## NORFOLK BOREAS examination

### Oulton Parish Council: Submission at Deadline 1

Summary of Issues raised and discussed in all OPC's Written Representations that were submitted to the examination of **Norfolk Vanguard**:

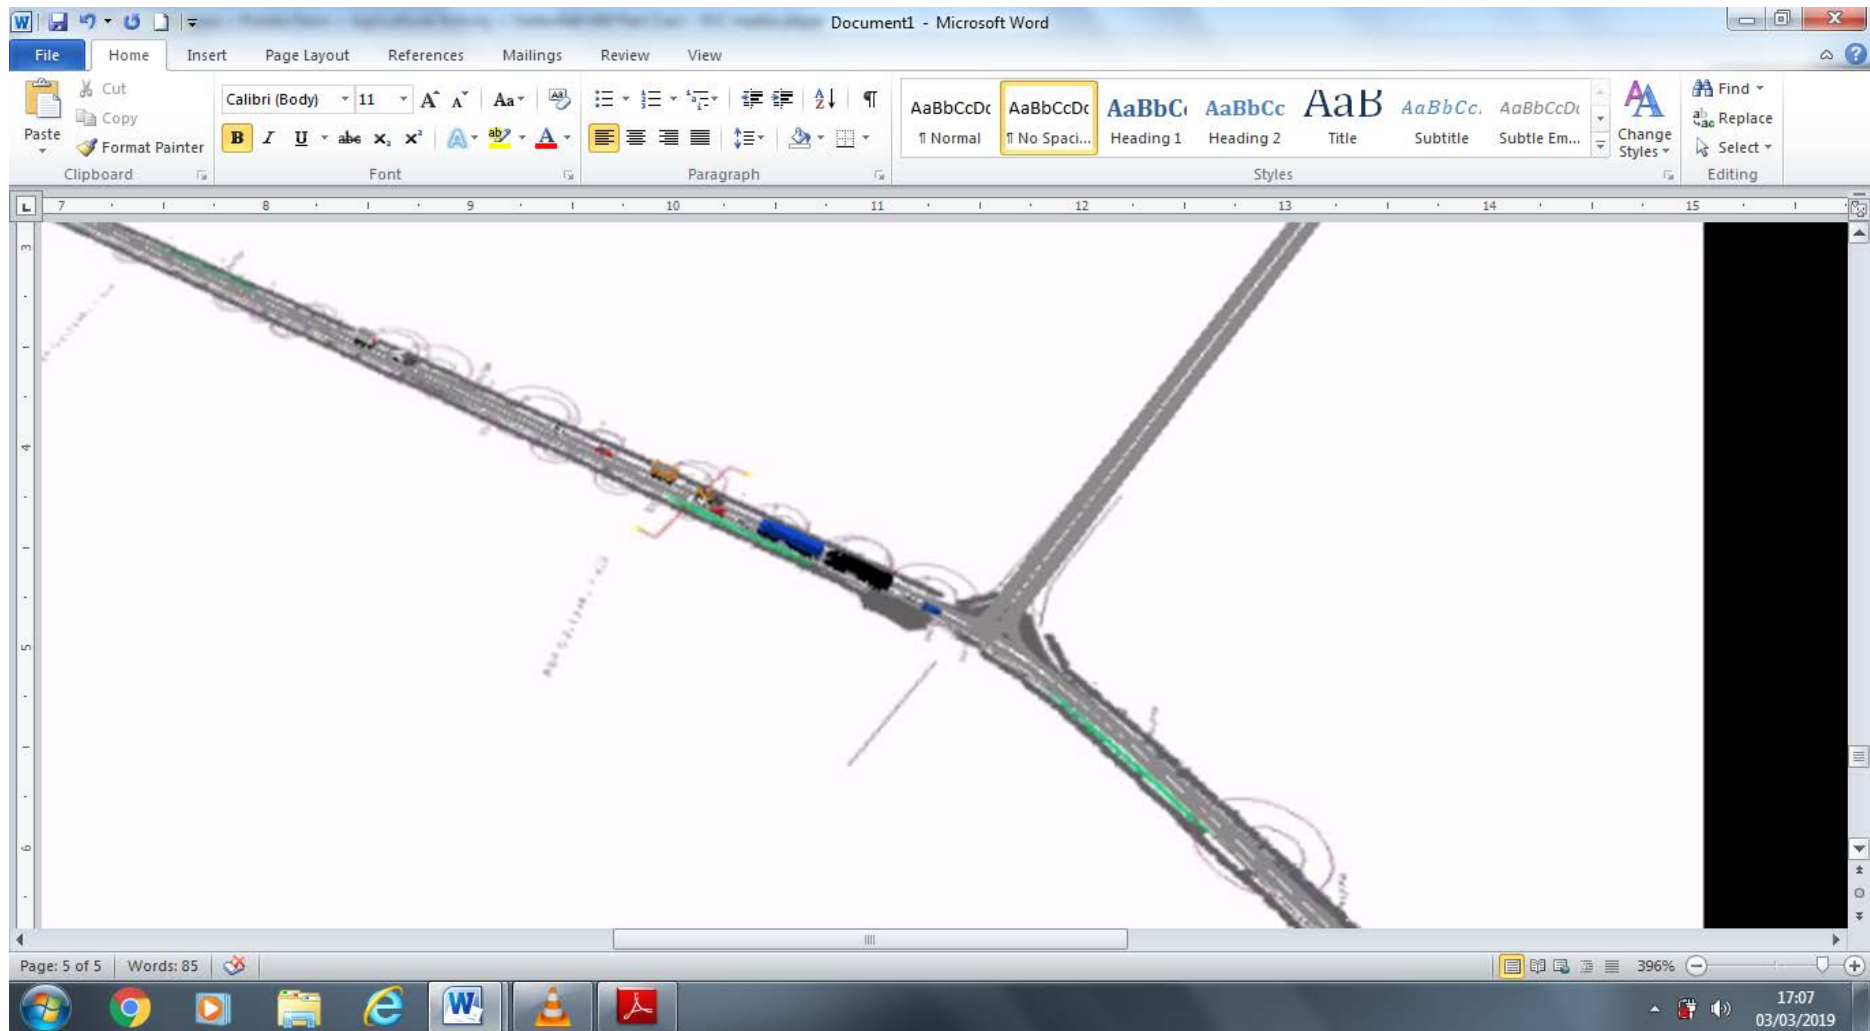
(ABOVE) Two tractors outside old railway gatehouse, potential for vehicles to overrun side of road and, in any case, the road width proposed makes such a passing impossible.

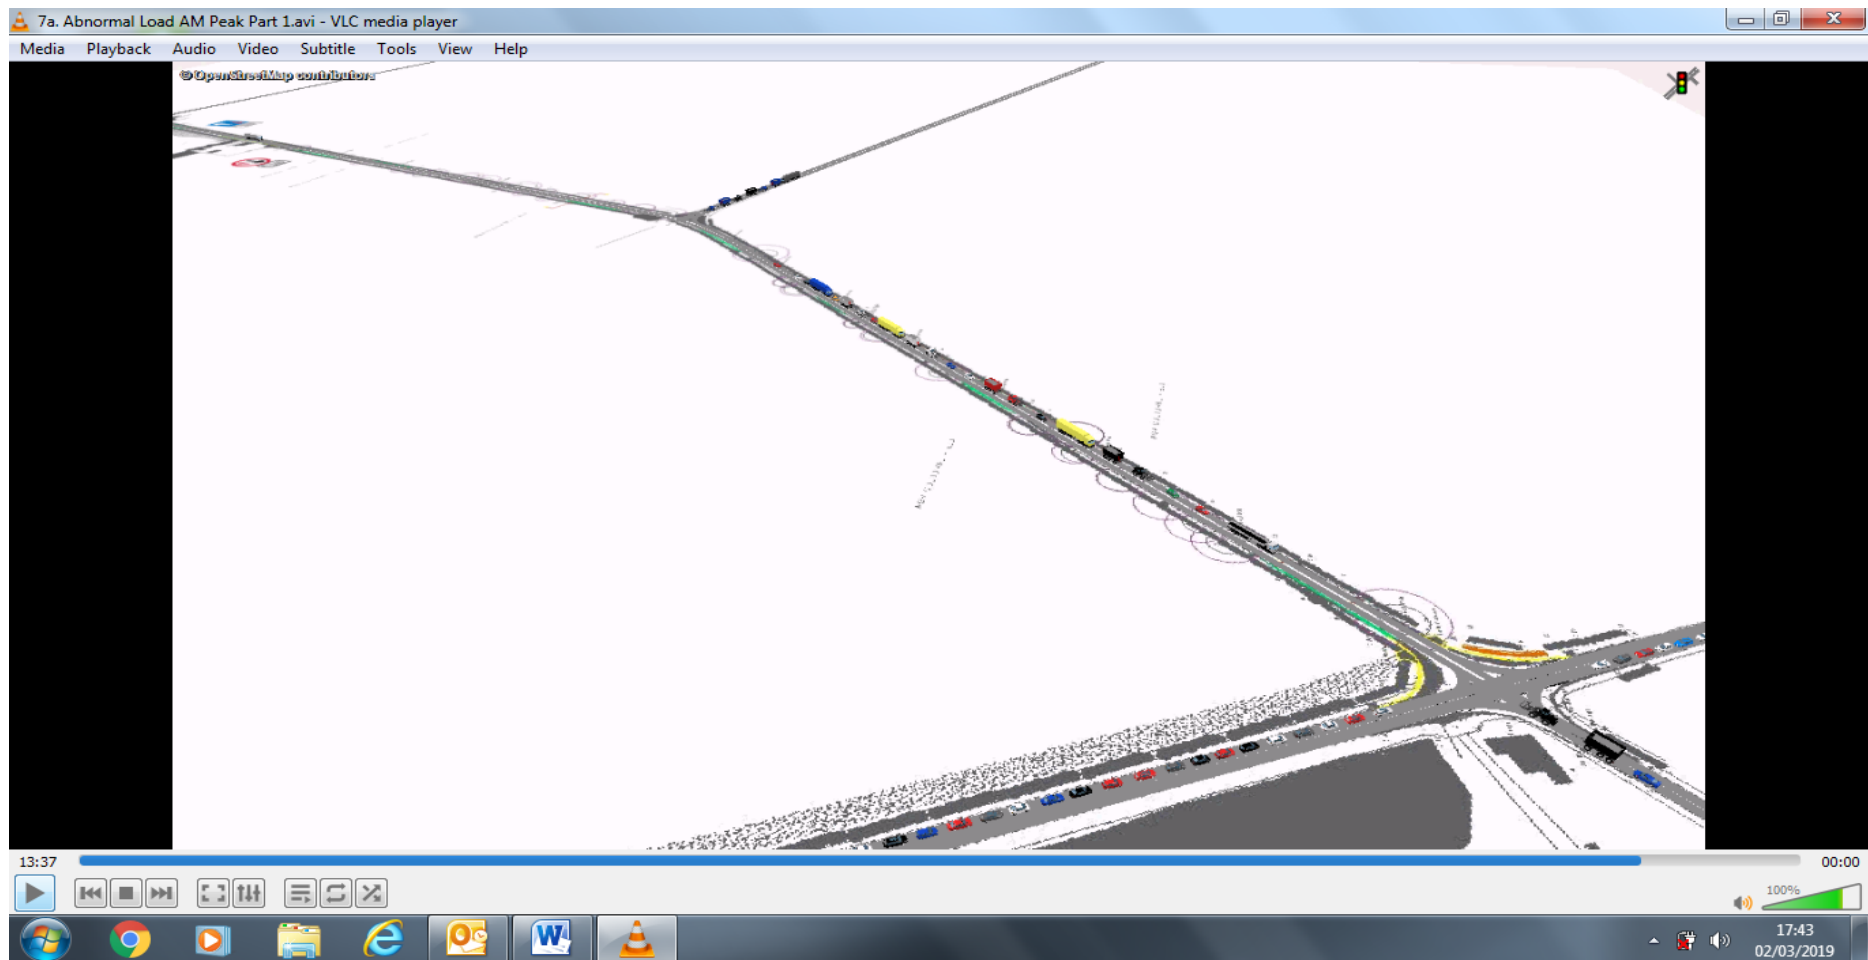
( Above) Enlarged view of bend. [6b 2028 Base + Hornsea + Potato Farm + Agricultural activity + Vattenfall AM part 2]...shows 2 cars 1 HGV in passing place 1 HGV & 2 Cars outside of passing place at bend, waiting for oncoming traffic.(3.33sec)

## Trenching of B1149

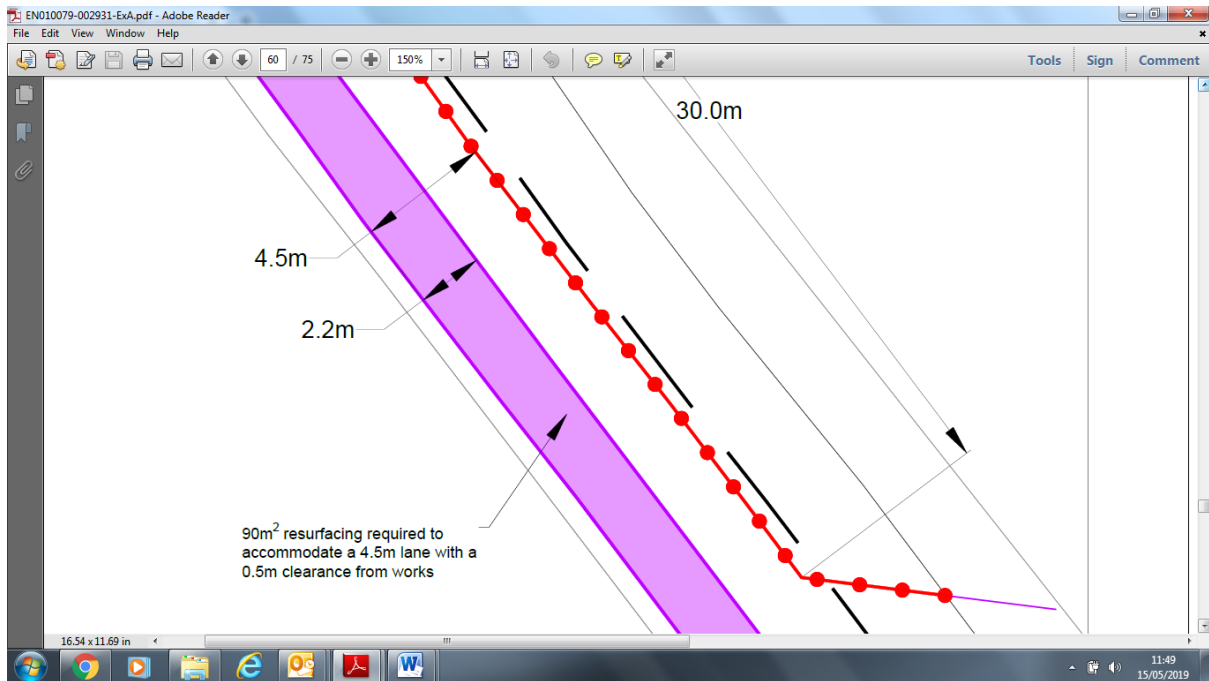
OPC note that the applicants propose to create a single lane width of 4.5m this is to accommodate abnormal loads. To achieve this 2.2m will be needed to widen the road. This appears to give 0.1m margin for error as the cable drums for HOW3 will be 4.4m wide; this also does not take into consideration large and wide agricultural vehicles.

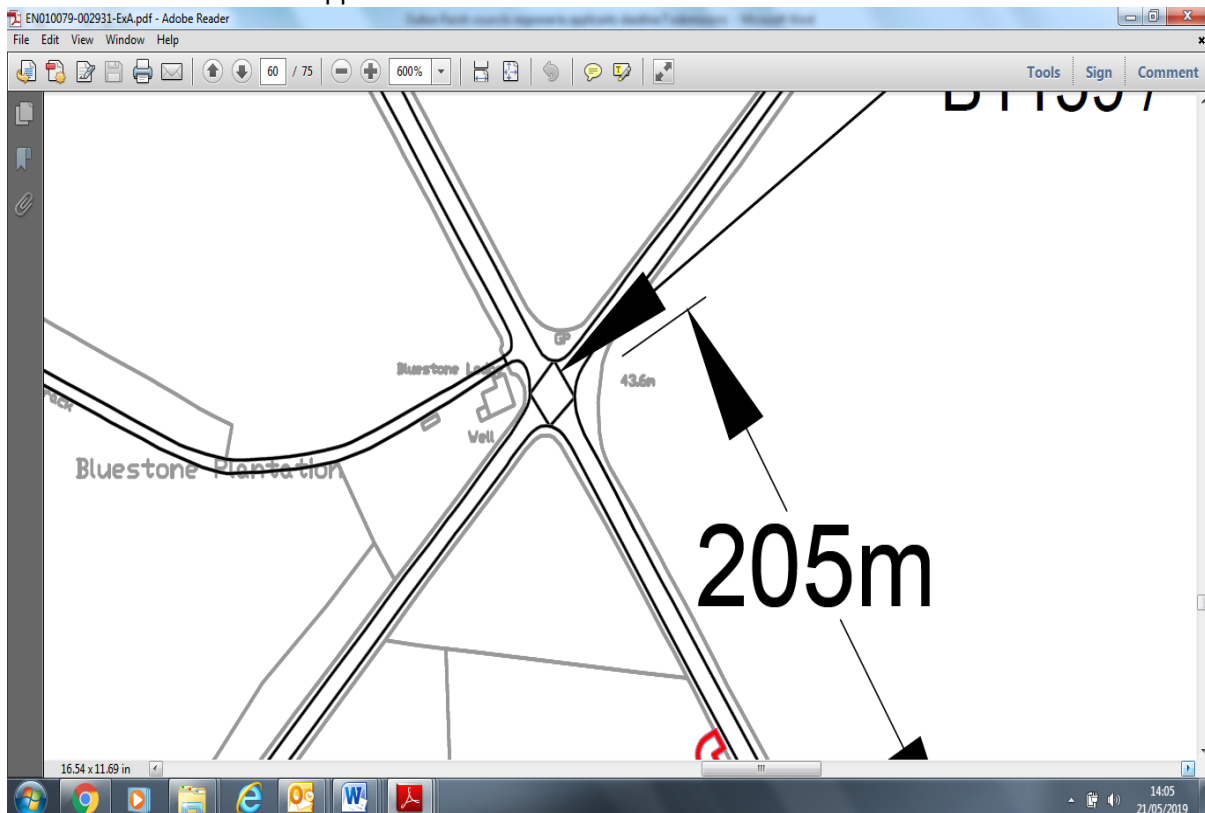
The road layout below shows that there will be 205m between the Junction B1149/The Street and the road works. OPC observe that the road intervention scheme widening of the junction will result in a reduced distance due to the Bellmouth entrance at the junction. It appears that the plan used

does not include the modifications. OPC also question whether the traffic works during trenching will result in tail backs at the junction and to the hump back bridge on B1149 especially if there are ALL arriving and departing from HOW3 Main Compound. OPC have already highlighted this issue in regard to the VISSIM modelling and the very real dangers this would present.

Junction appears to be shown without the bellmouth modifications.
